PCN: V13-004-480035-0A

Product Change Notice

Change 1: Change of platform from ceramic to metal leadframe at a newly qualified supplier for Quad Flat (Minipak) package family.

Dimension Comparison between Ceramic substrate and lead frame

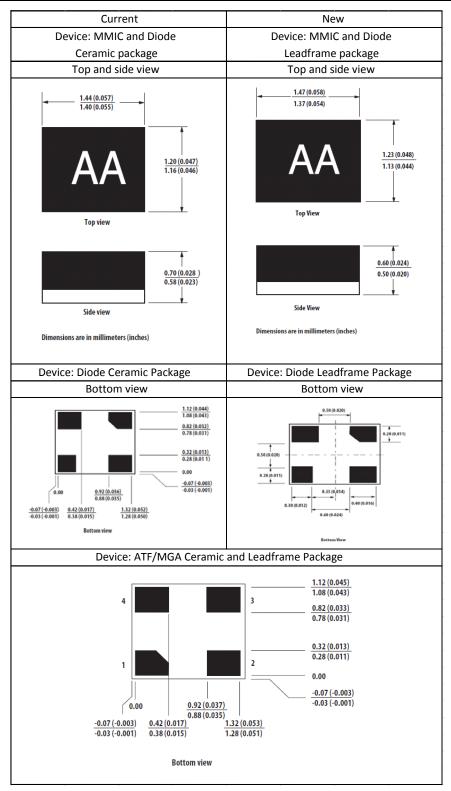
There will be a slight change in the product outline dimensions in moving from ceramic to lead frame. Please review page 2 for details. However there will be no impact to stencil and package footprint for the pcb.
